Product Change Notification PCN_BUR_00200

Subject: new extended shroud for our Eaton's DMV switch-disconnectors

New EXTENDED-COVERDMVS160N/400N
fitted on a DMV switch-disconnector

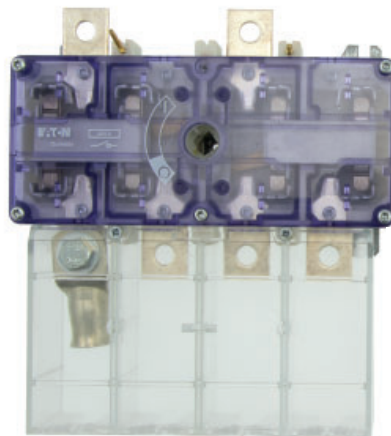
We are pleased to inform you that our new extended shroud (Y7-400894; EXTENDED-COVERDMVS160N/400N) for DMV 160N, 250N and 400N is now available. This new cover is extended to further cover the cable terminals and lugs for increased personnel safety.

It is replacing the old cover (Y8-1314735; COVERDMVS160N/400N). This change is with immediate effect.
